# Local Planning Panel

59-99 Belmont Street, Alexandria

D/2019/1249

# proposal

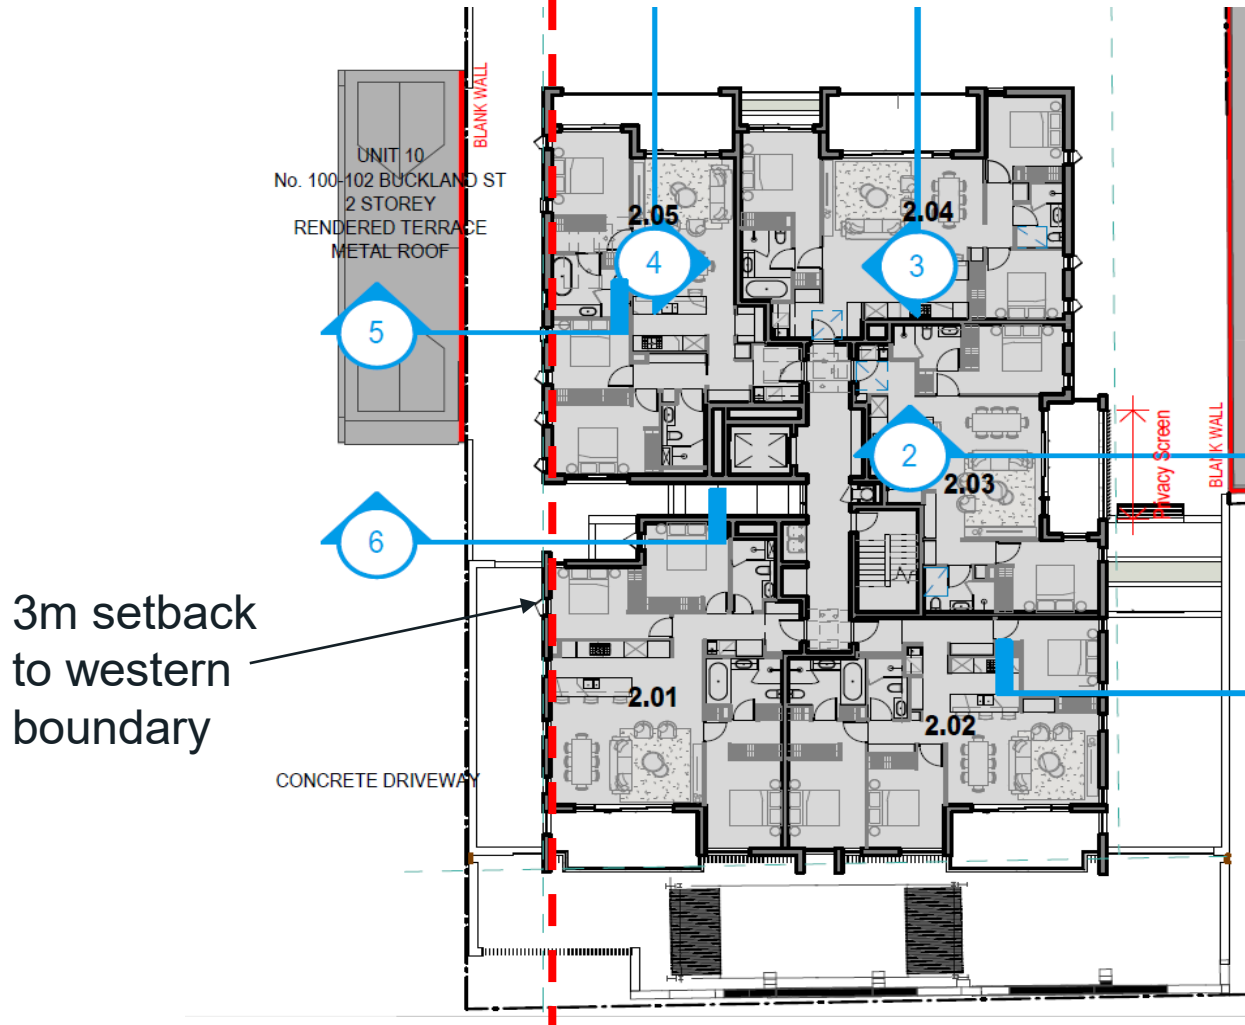
reviewed application on 4 February 2020. Panel raised concerns with the original proposal including:

- tree loss to facilitate driveway entry
- orientation of terraces to Belmont Street did not optimise solar access or activate through site link

These issues have been addressed in amended plans

Section Diagram\_5

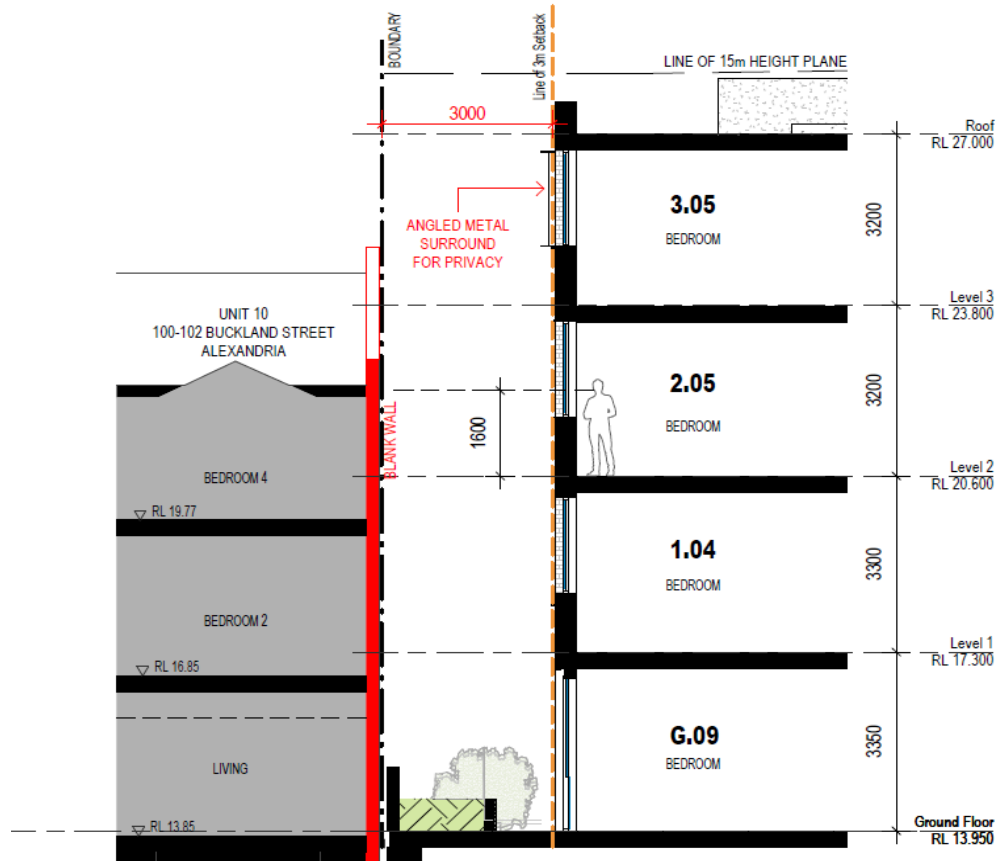
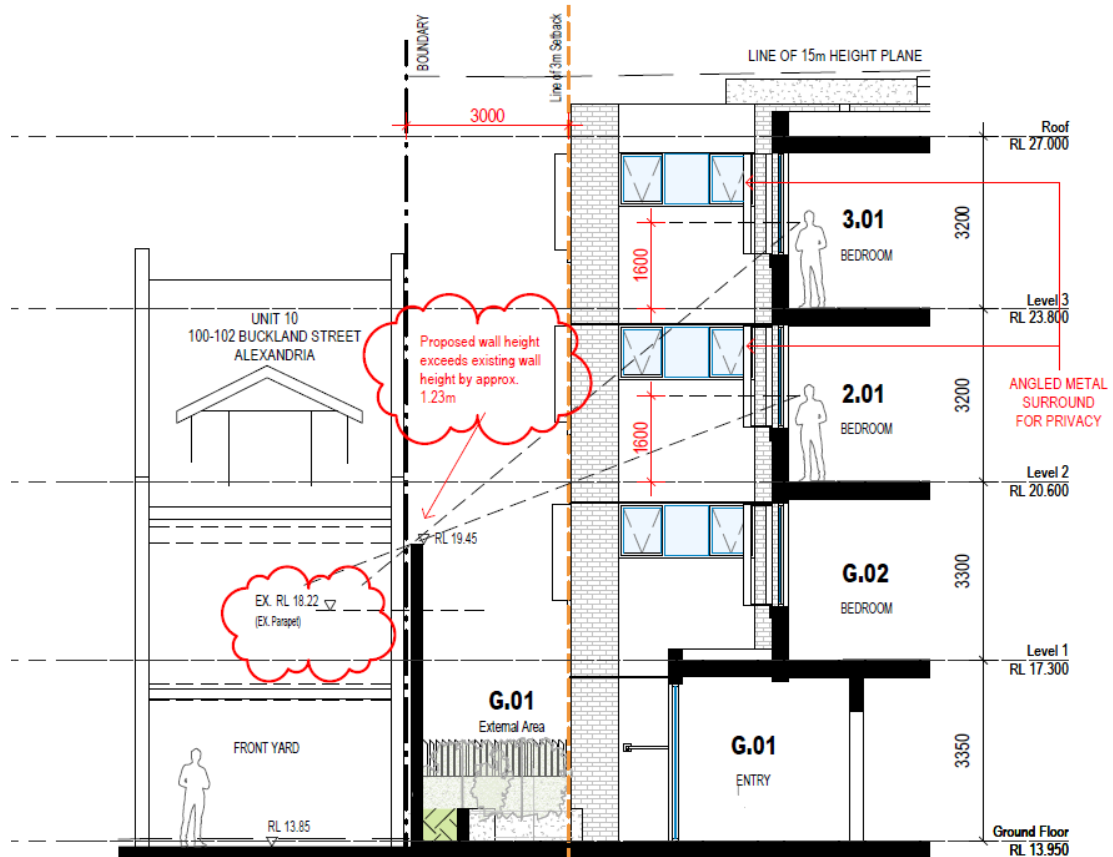
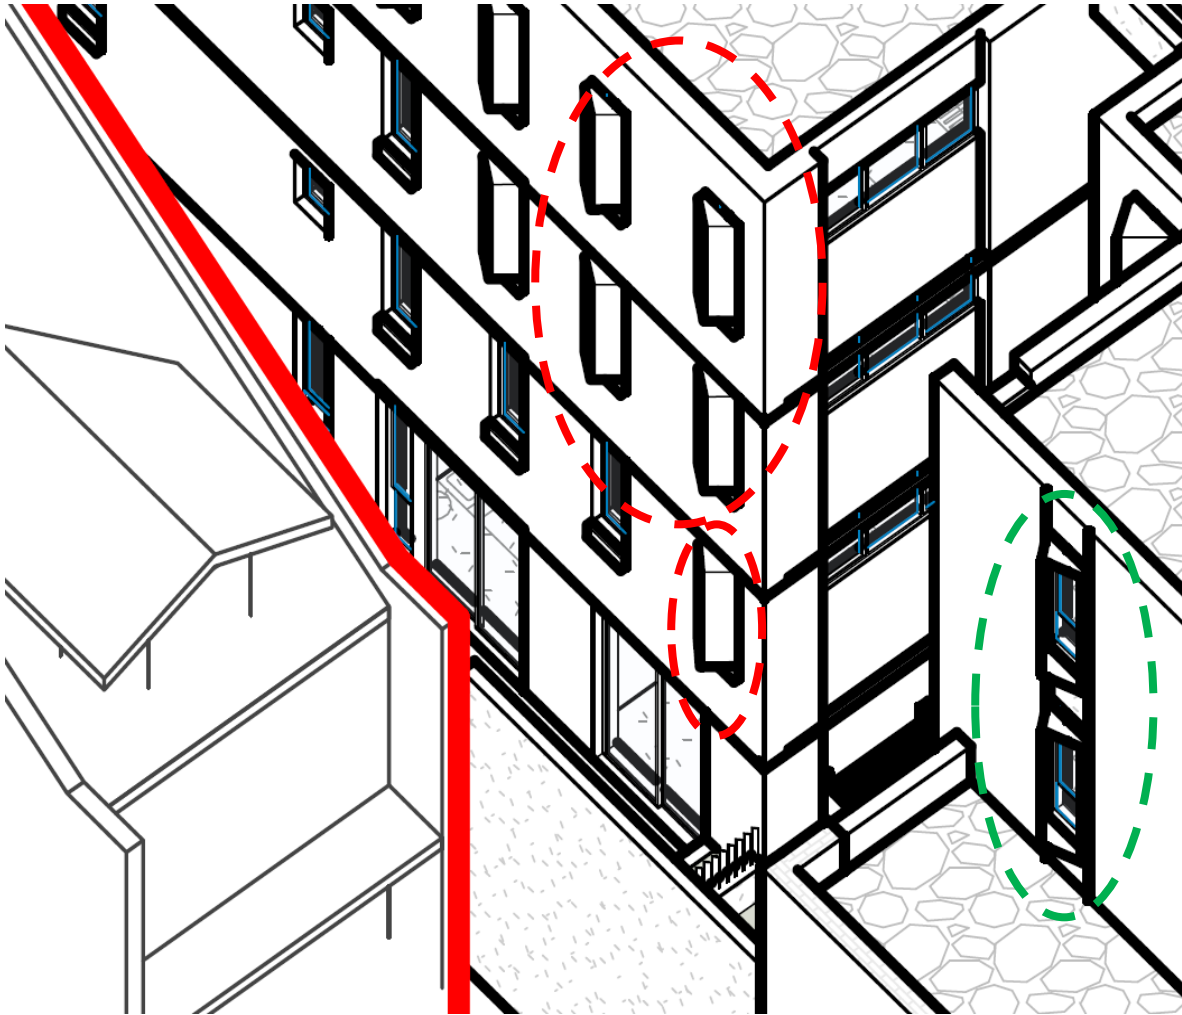
building generally aligns with blank wall condition and driveway

3m setback to western boundary

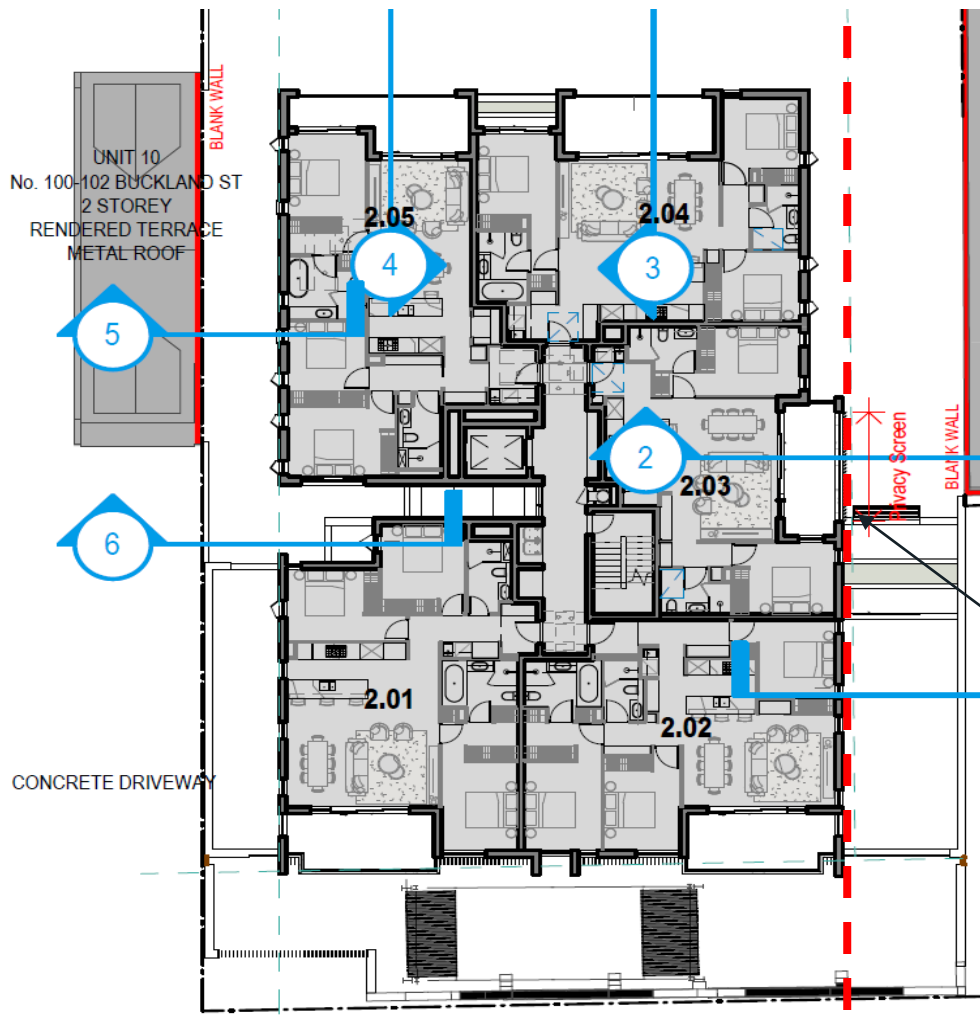
condition recommended  
to turn window hoods  
circled in red to face  
Belmont Street (like  
windows circled in green)

Section Diagram\_2

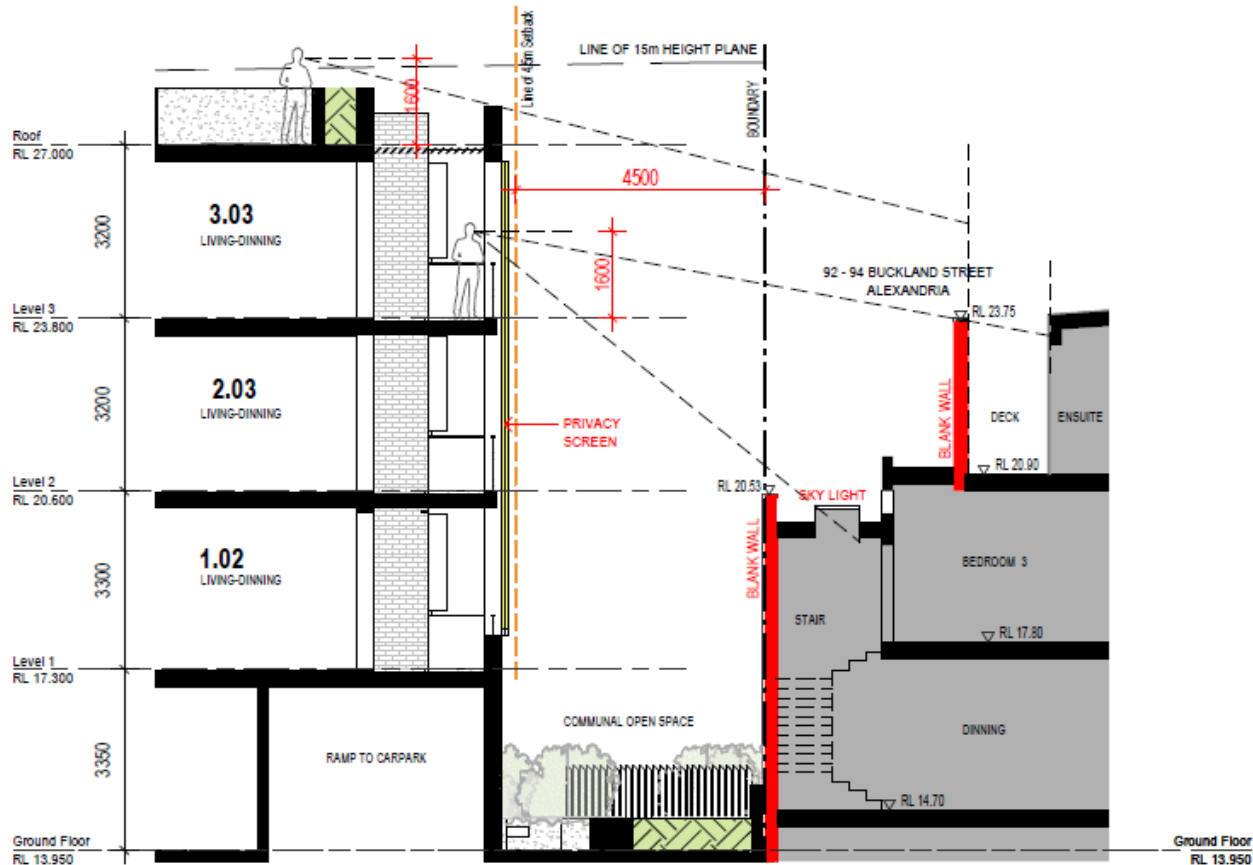
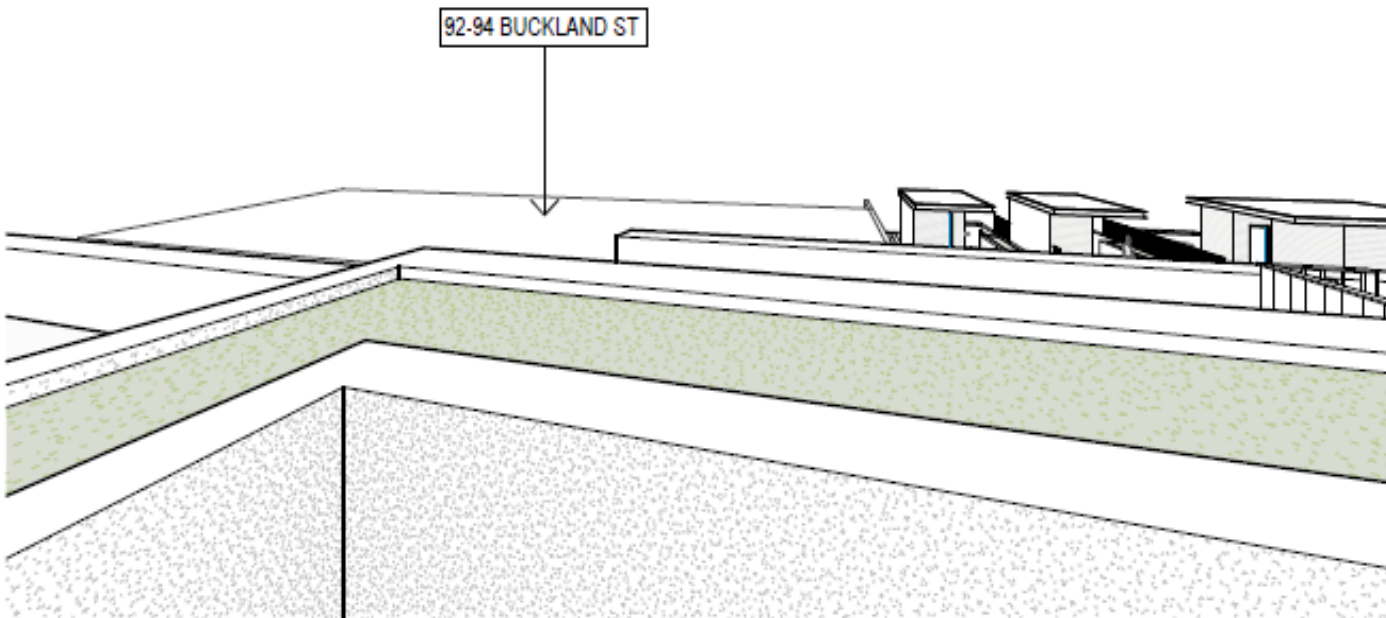
building generally aligns with blank wall conditions, and privacy screen provided

4.5m setback to eastern boundary

Section Diagram\_3

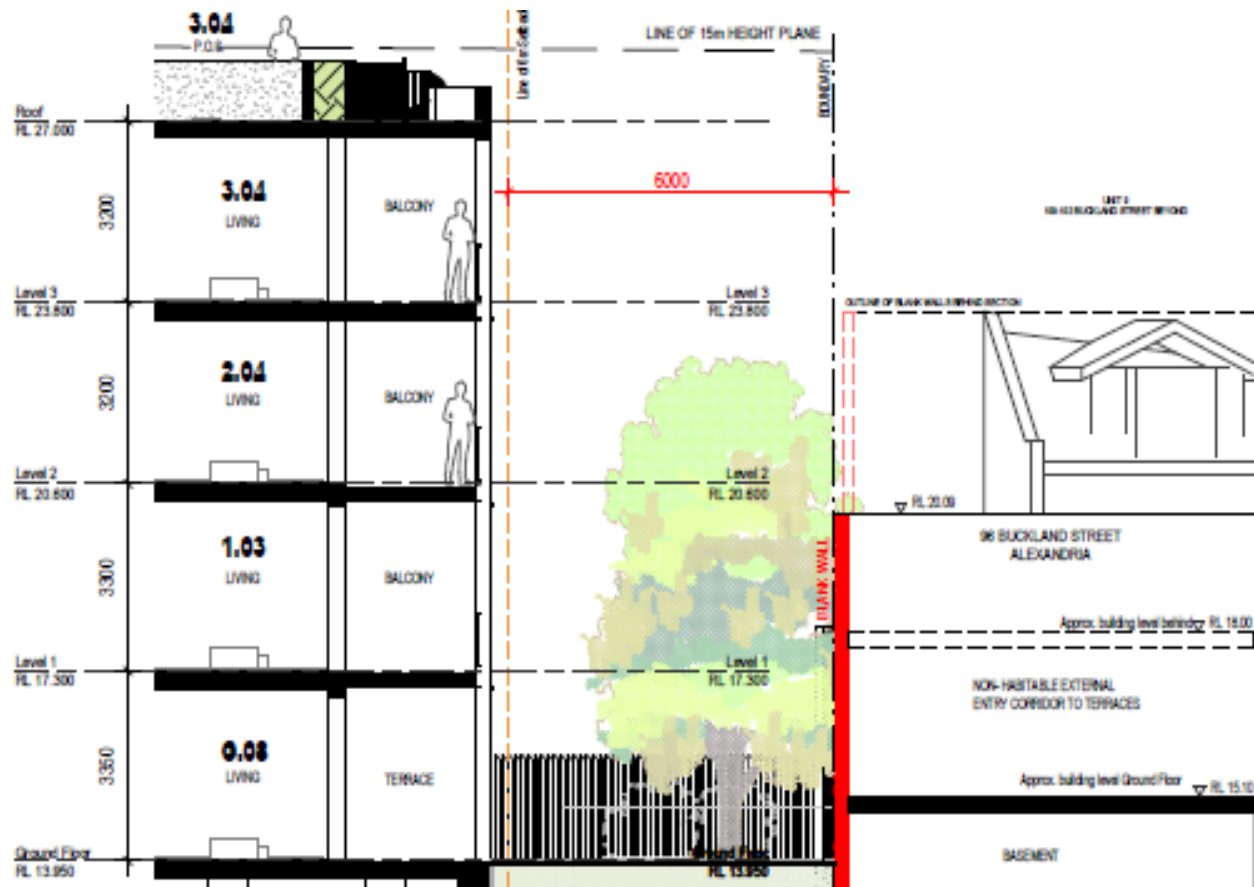
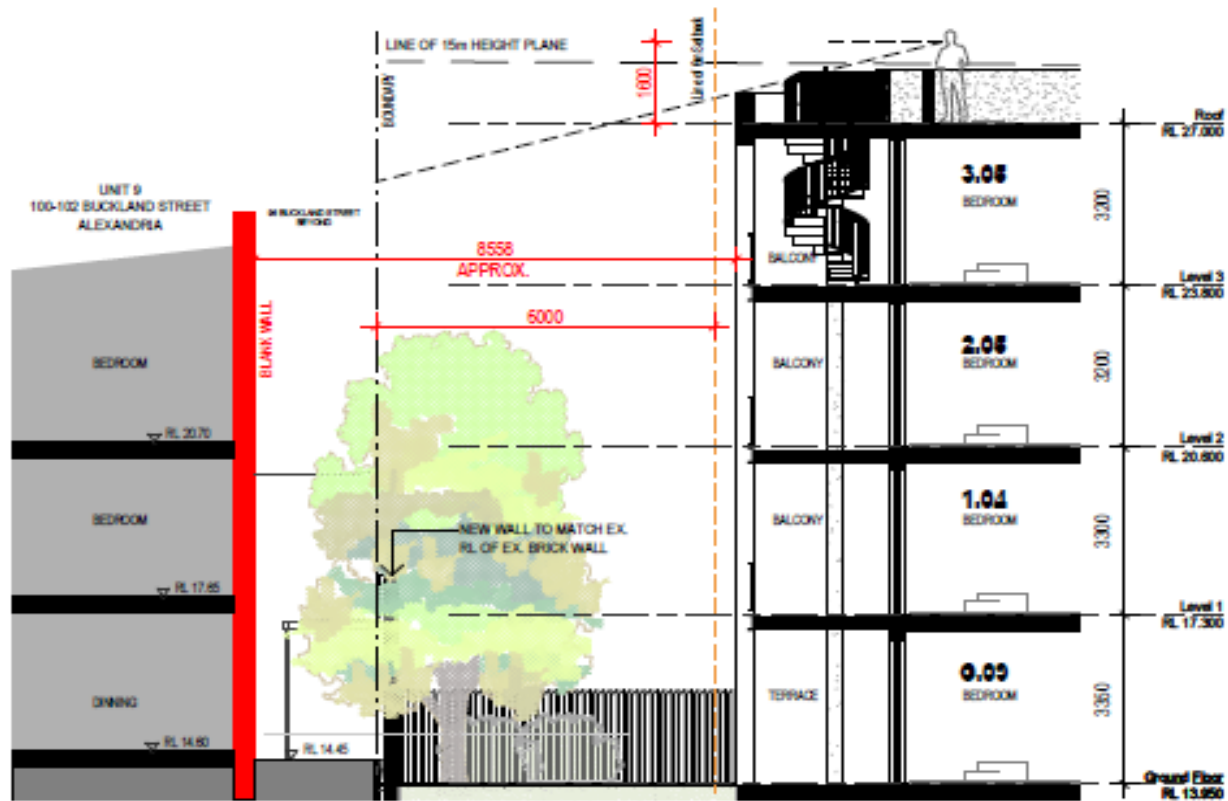
6m setback – compliant with ADG
